Bullock Creek School District
2024 Bond- Series 2 - 2027 Renovations
HS / MS / Floyd and Pine River Elementary Schools

ADDENDUM #1

Project: No. 26-210 Bullock Creek 2023 Bond Series 2
2027 Improvements

Issue Date: November 2, 2026

SEAL	DRAWN CJV/KLS	PROJECT NO. 26-210
	CHECKED KLS	CAD FILE NO. B-M108
	REVIEWED MLB	DRAWING NO. B-M108
	DATE OCT 19, 2026	SHEET NO. 20 OF 38
	SCALE AS NOTED

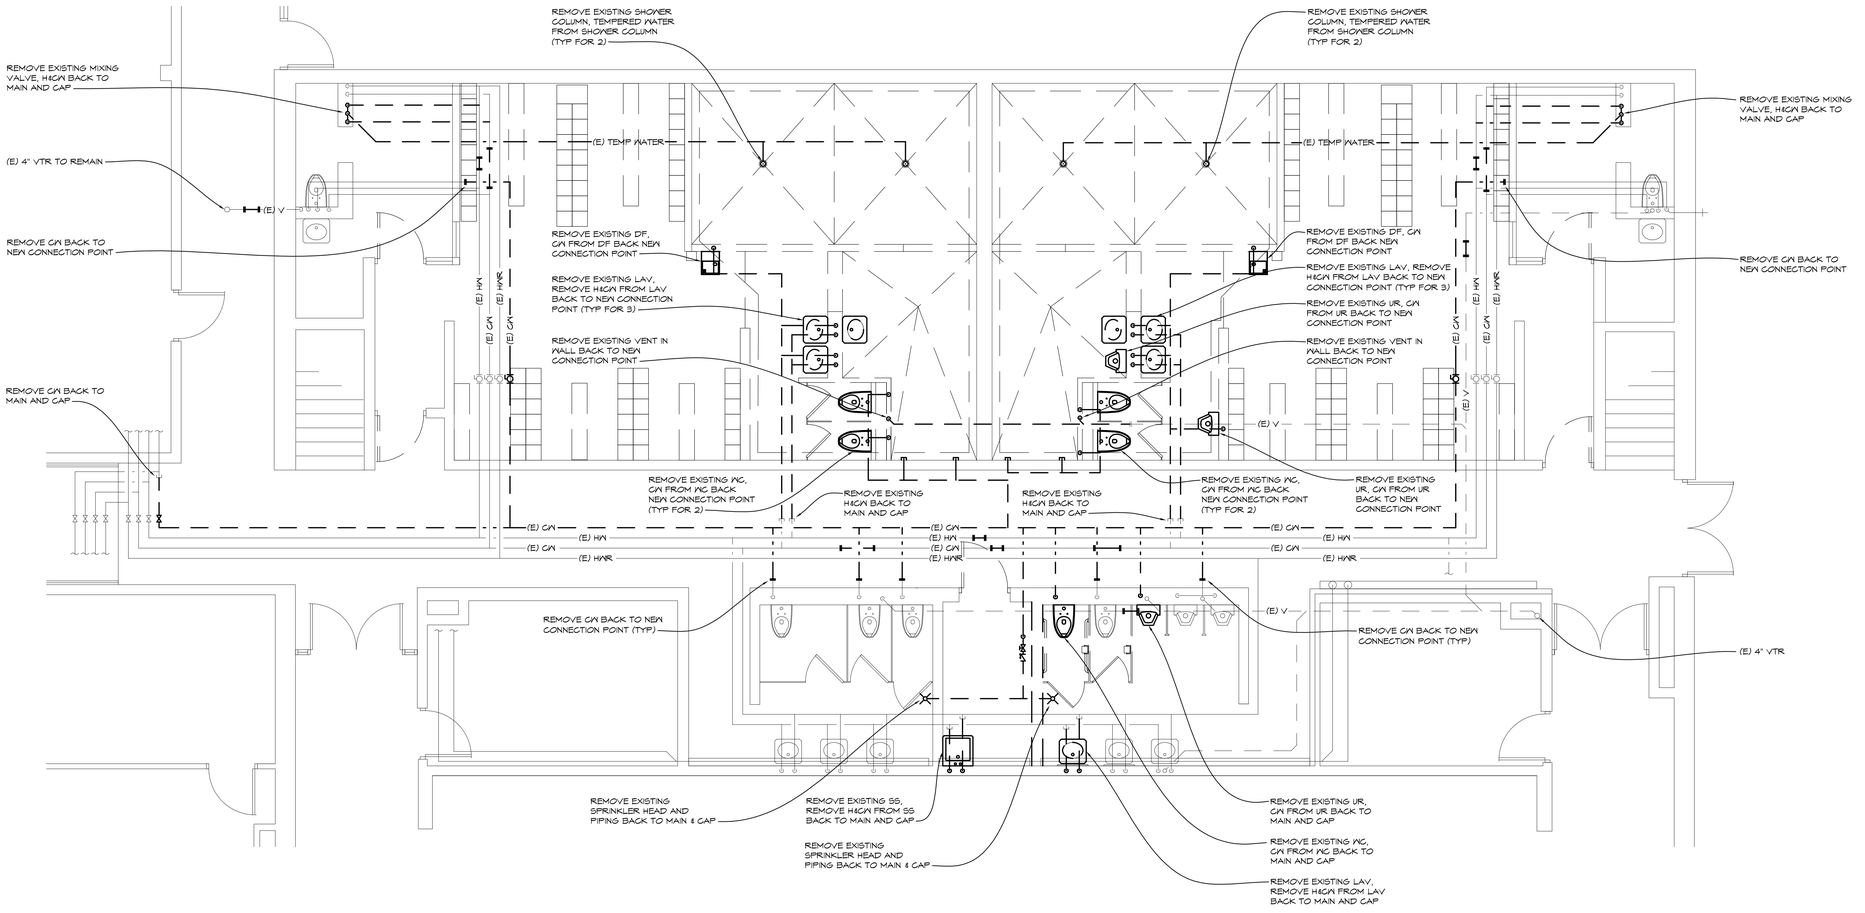
Item #M9: Revise Sheet B-M108 as follows:

a. Keyed Mechanical Demolition Notes revised.

SEAL	DRAWN CJV/KLS	PROJECT NO. 26-210
	CHECKED KLS	CAD FILE NO. B-P102
	REVIEWED MLB	DRAWING NO. B-P102
	DATE OCT 19, 2026	SHEET NO. 24 OF 38
	SCALE AS NOTED

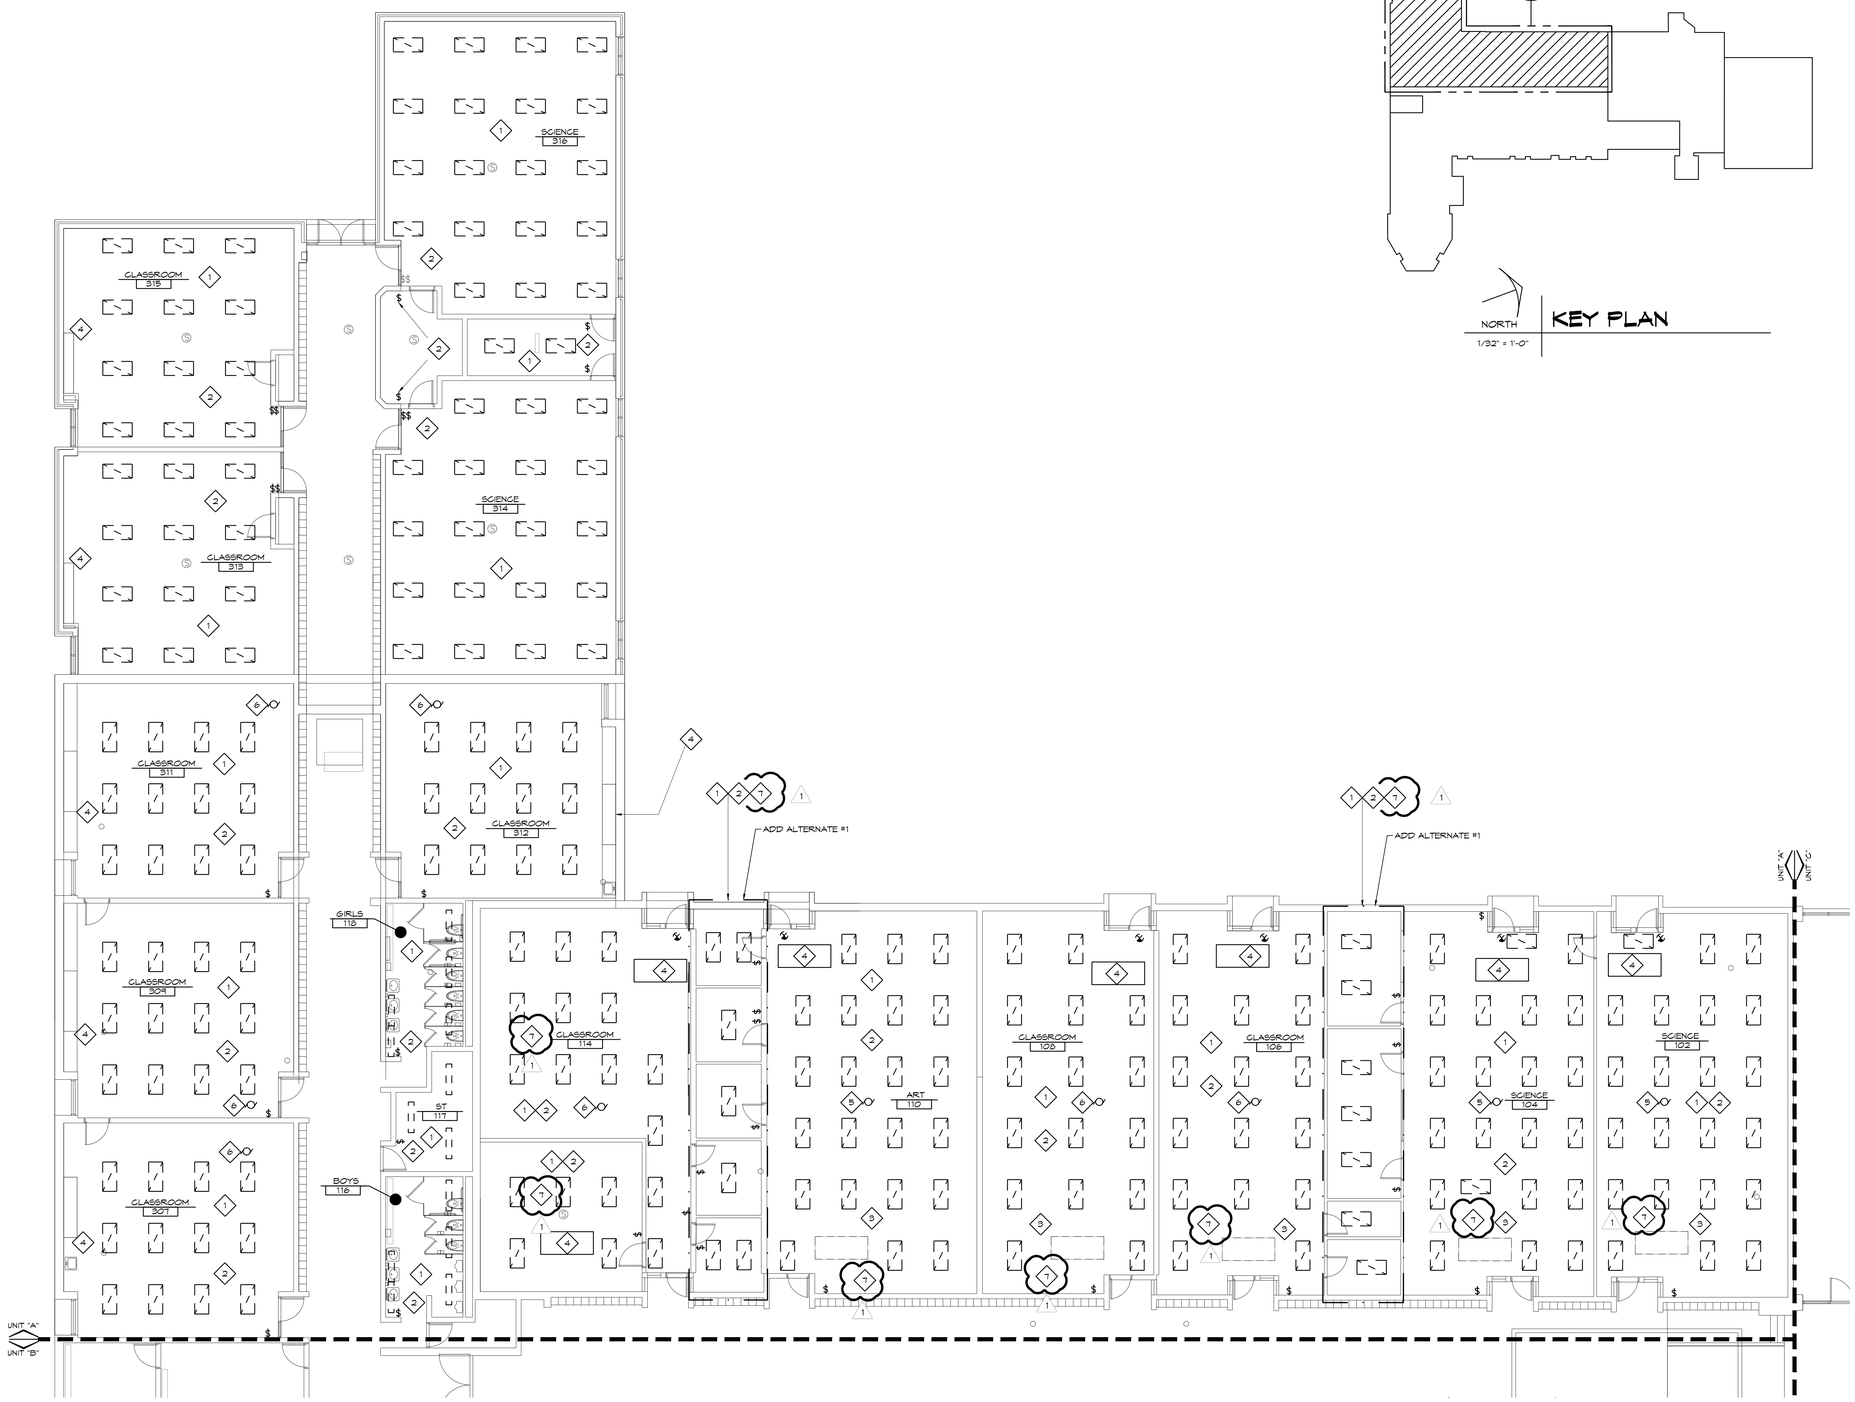
Item #P6: Revise Sheet B-P102 as follows:

a. General Note "ALL PIPING INSULATION TO BE REMOVED BY OTHERS" added to Plan.

DRAWN TJA	PROJECT NO. 26-210
CHECKED RGH	CAD FILE NO.
REVIEWED RGH	DRAWING NO. B-E102
DATE OCT 19, 2026	SHEET NO. 29 OF 38
SCALE

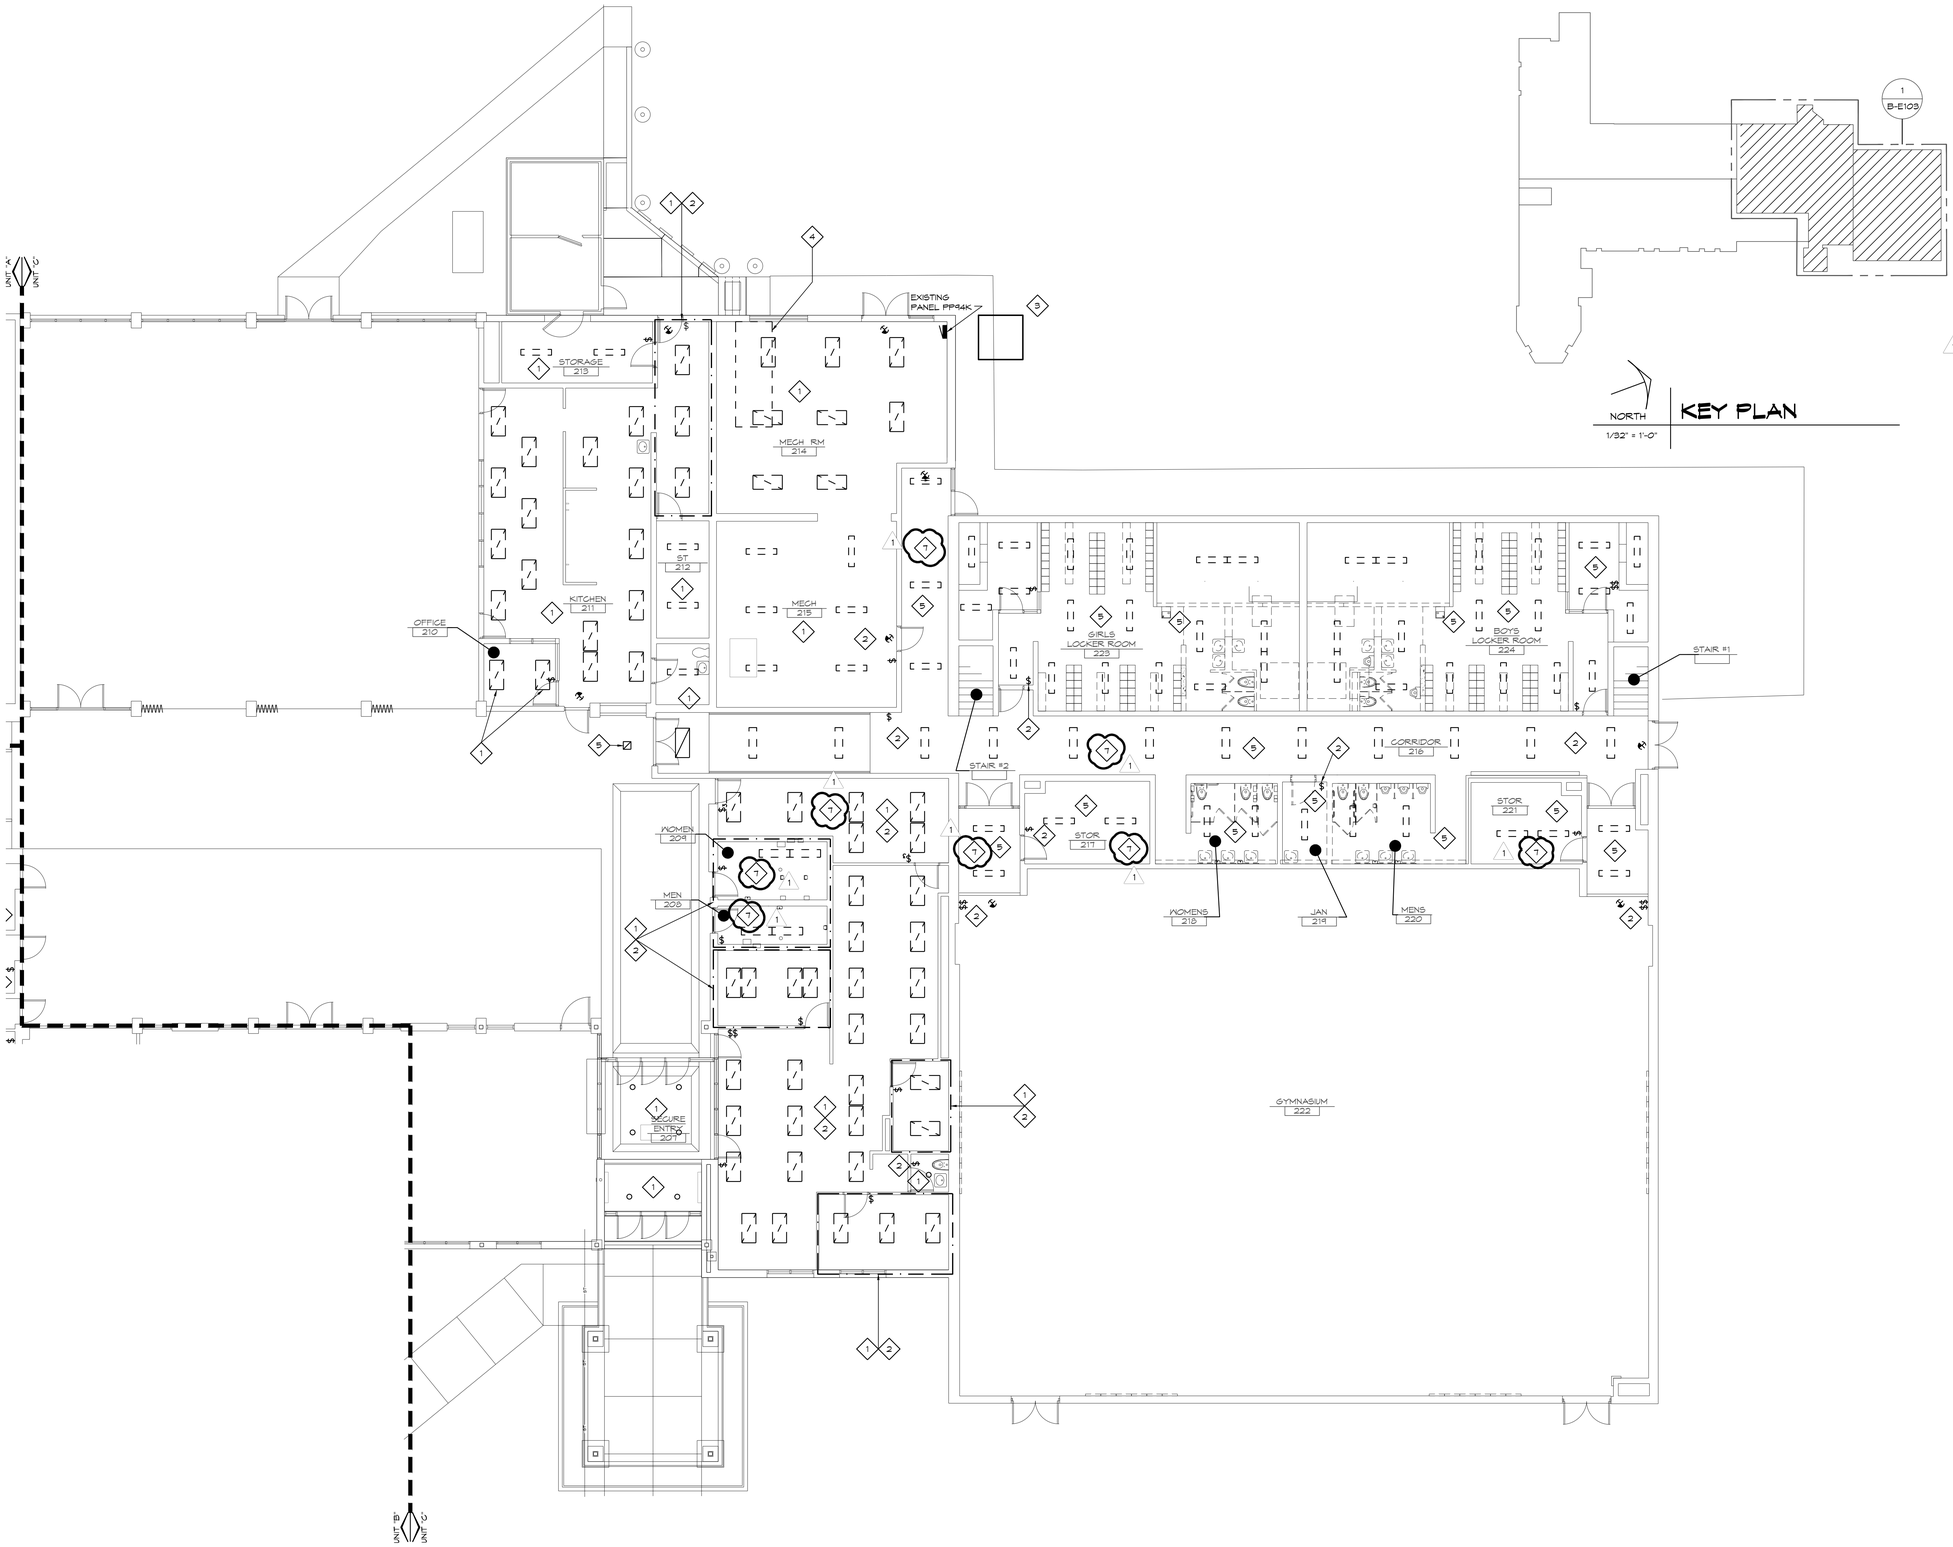
Item #E5: Revise Sheet B-E102 as follows:

a. Added Note for remove and reinstall fire alarm devices on new ceiling for all spaces in scope of work.

SEAL	DRAWN TJA	PROJECT NO. 26-210
	CHECKED RCH	CAD FILE NO.
	REVIEWED RCH	DRAWING NO. B-E103
	DATE OCT 19, 2026	SHEET NO. 30 OF 38
	SCALE

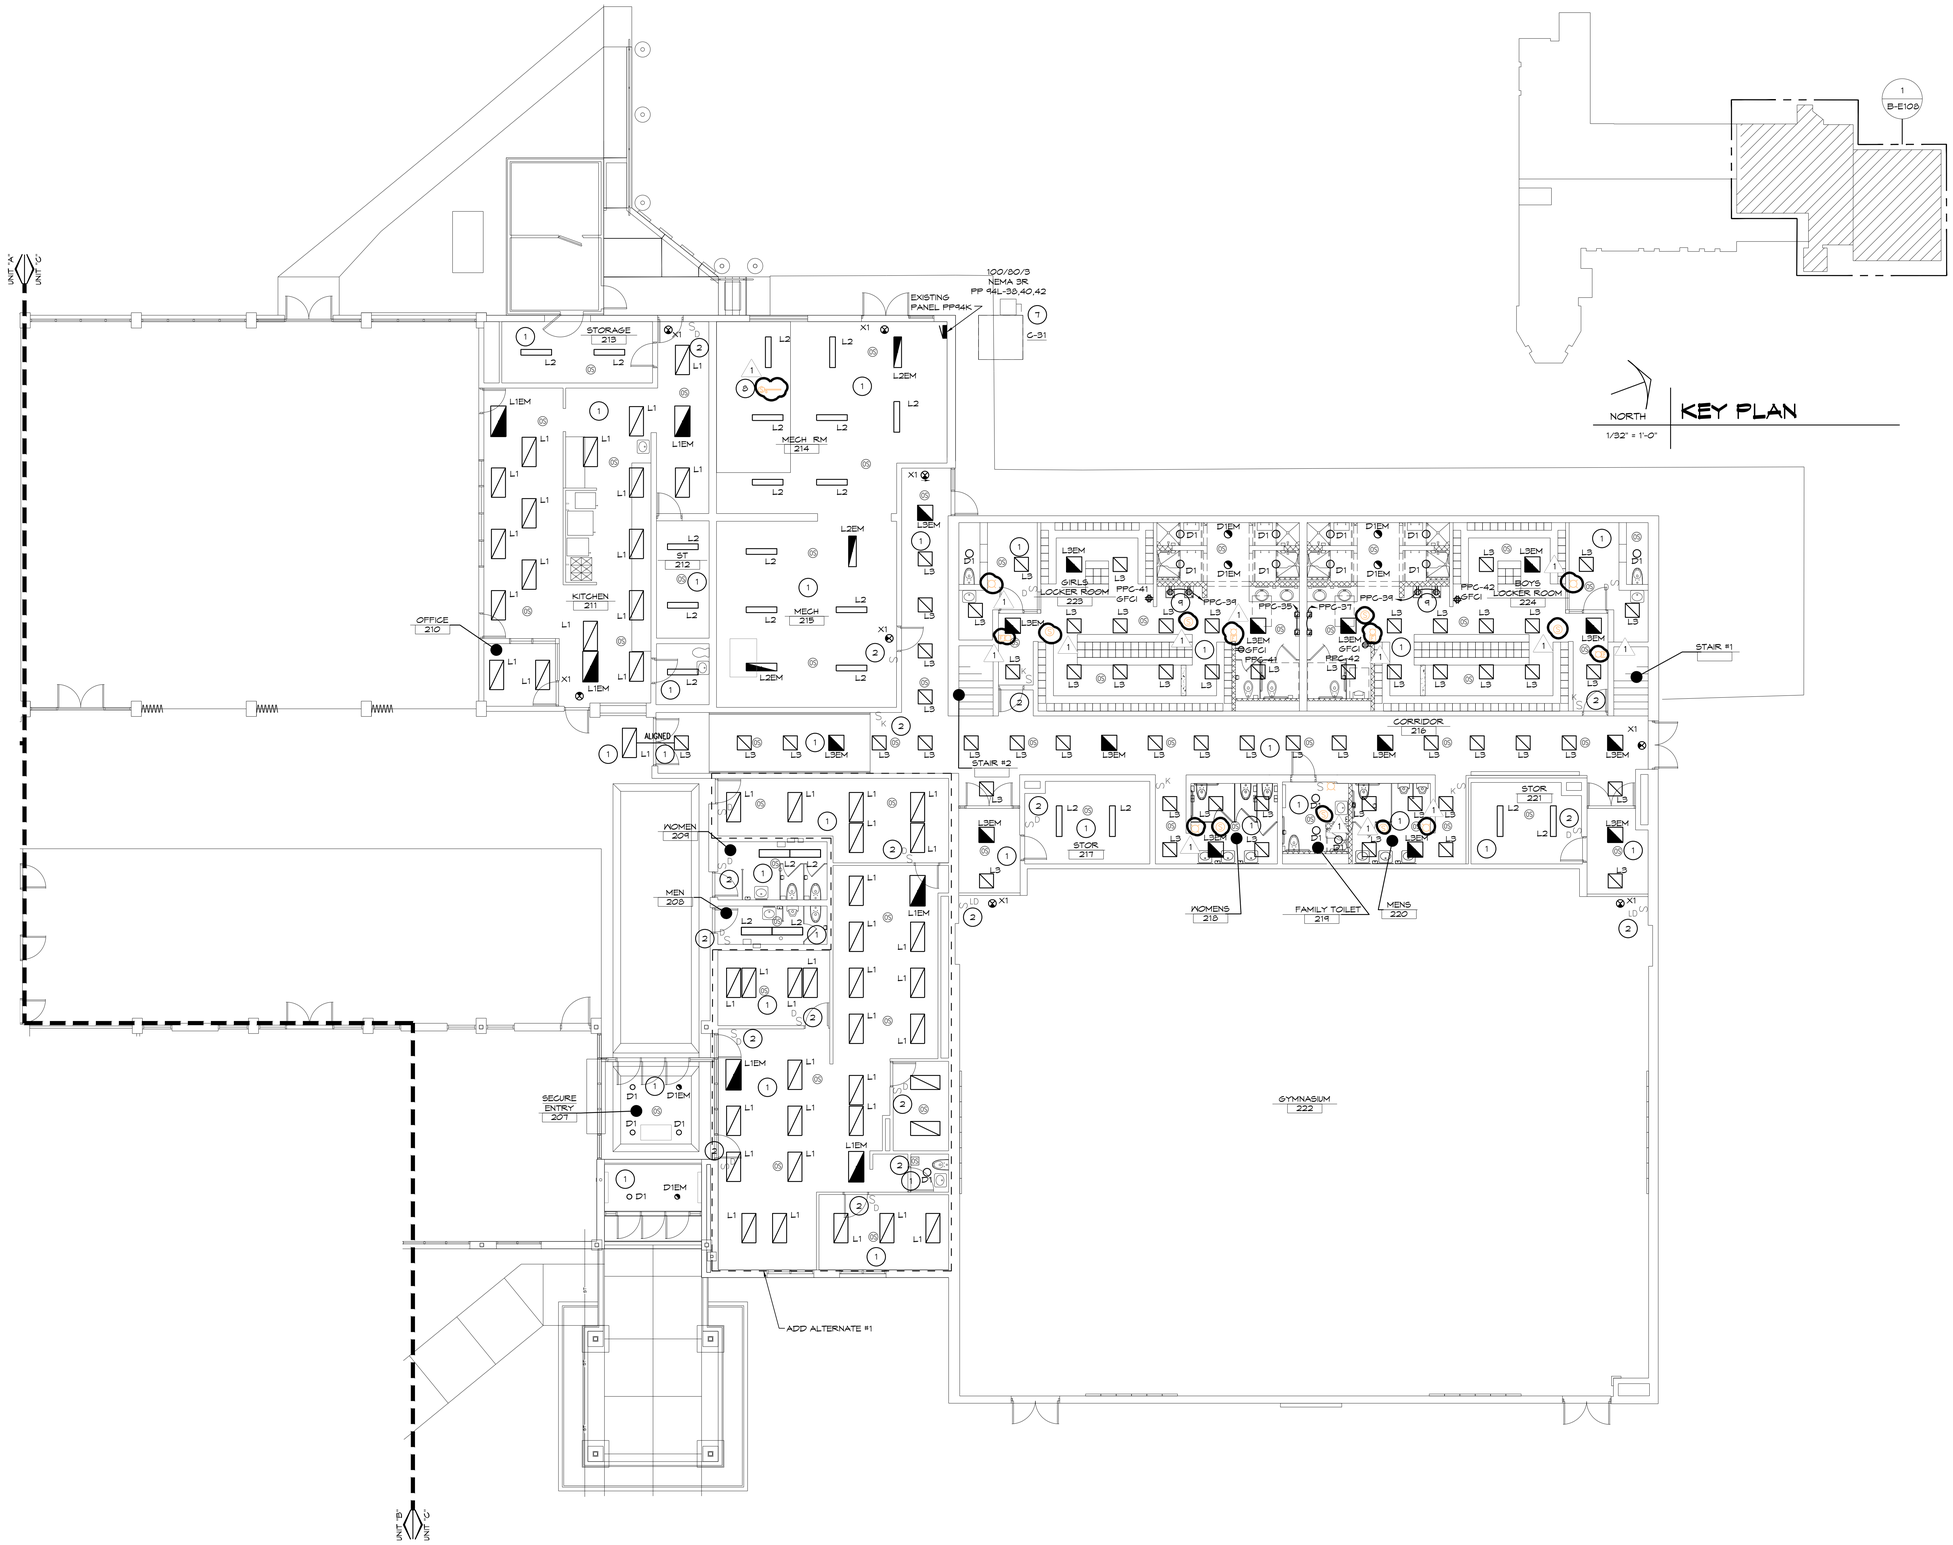
Item #E6: Revise Sheet B-E103 as follows:

a. Added Note for remove and reinstall fire alarm devices on new ceiling for all spaces in scope of work.
